MEETING NOTICE AND AGENDA
TECHNICAL ADVISORY COMMITTEE
OF THE
SEASIDE BASIN WATER MASTER

DATE: Wednesday, February 8, 2017

MEETING DATE:	February 8, 2017
AGENDA ITEM:	3
AGENDA TITLE:	Continued Discussion of Technical Memorandum Regarding Results from Resampling Verification of Wells
PREPARED BY:	Robert Jaques, Technical Program Manager
SUMMARY:	<p>At the January 11 TAC meeting there was initial discussion of HydroMetrics' January 5, 2017 Draft Technical Memorandum - <i>Seaside Groundwater Basin Analysis of Wells Sampled in December 2016</i>. There was agreement that further discussion and revisions to the Draft were in order and that the topic would be continued over for discussion at today's TAC meeting.</p> <p>Attached is a revised Final Draft version of the Technical Memorandum addressing the issues raised at the January 5 TAC meeting. At today's meeting the TAC is asked to either approve this as the Final version of the Technical Memorandum, or request final revisions to be made to it.</p> <p>Once the TAC is satisfied that the Technical Memorandum provides a clear and understandable presentation of the findings from the resampling of the Sentinel Wells, it will be presented t

Figure 6: Piper Diagram for SBWM-2 (1,470 ft)

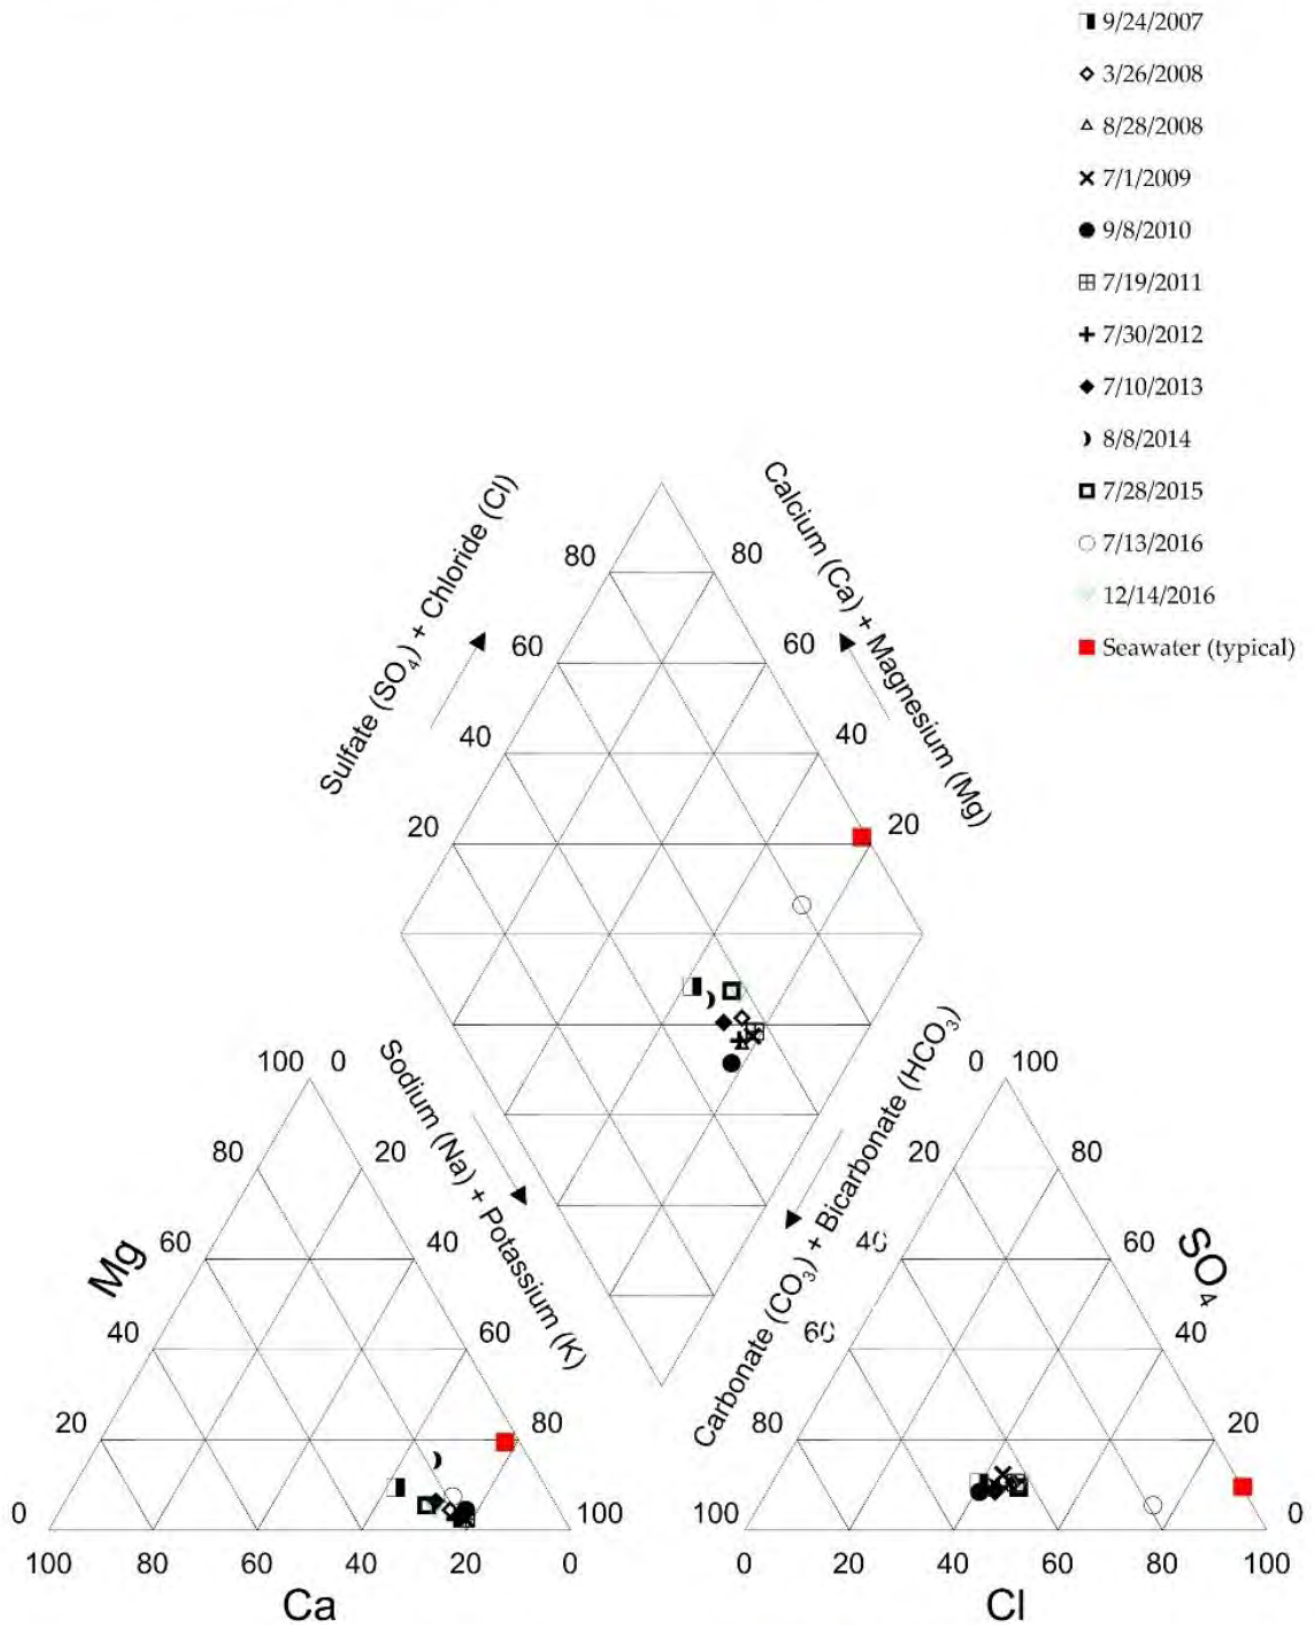
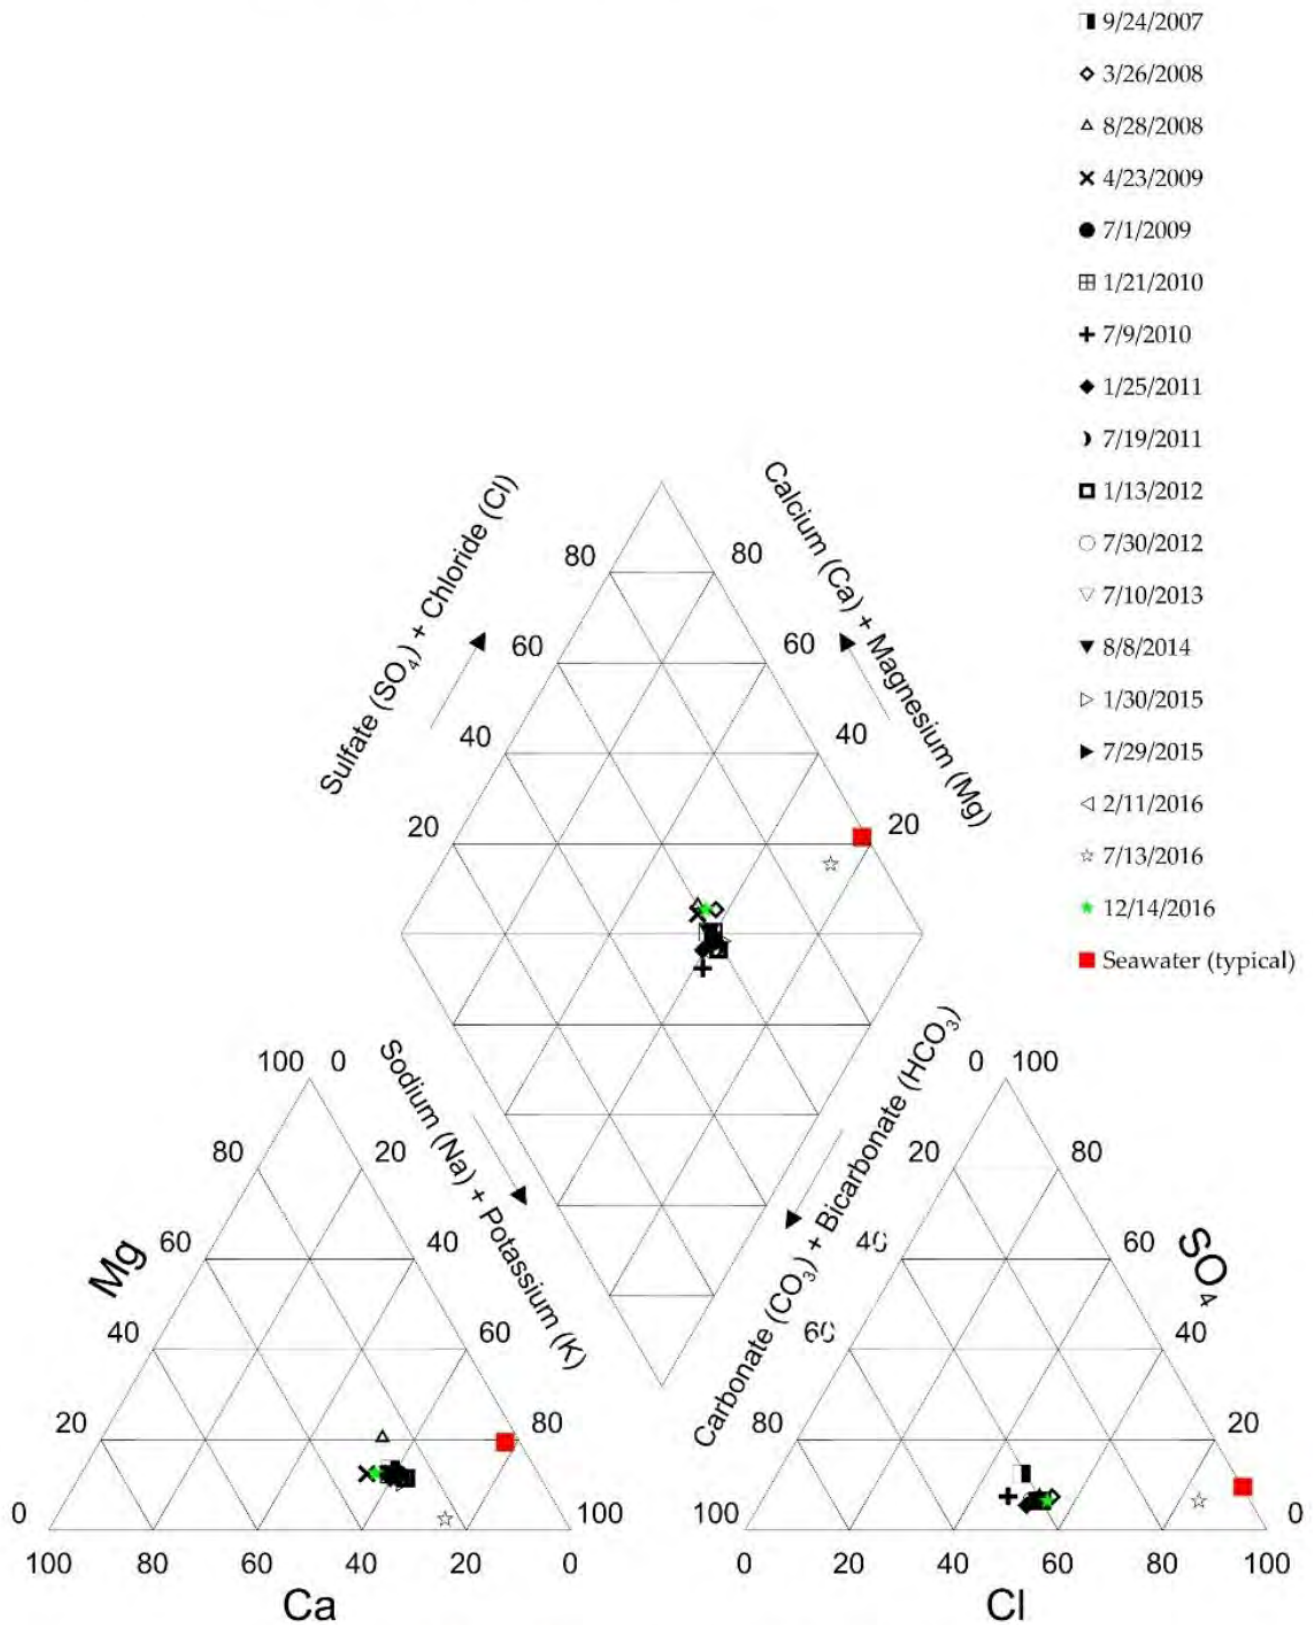
Ms. Voss said she had concerns about how the Piper and Stiff diagrams are being interpreted. She went on to say that Figures 6 and 7 in the Technical Memorandum do not show lateral seawater intrusion. She felt that these do not indicate seawater intrusion is occurring, rather it is an indication of mixing or degradation of waters from other sources, but not lateral seawater intrusion. She felt that the July data was "a bad data point" and should not be used. Mr. Williams felt there was a need to find a better way to explain this in the Technical Memorandum.

Mr. Hulbert requested that revisions to the Technical Memorandum be made based on today's

1. More work needs to be done to revise and clarify/refine the Technical Memorandum, so it will be clearer and more conclusive.
2. The Watermaster's consultants all agree that the data is not a clear indicator of seawater intrusion.
3. The groundwater quality fluctuations that are being observed can be caused by several things.
4. Sampling should be continued to determine if the fluctuations are an ongoing phenomena or something that is temporary in nature.
5. A work plan should be prepared to define an approach to determine the causes of the groundwater quality fluctuations.
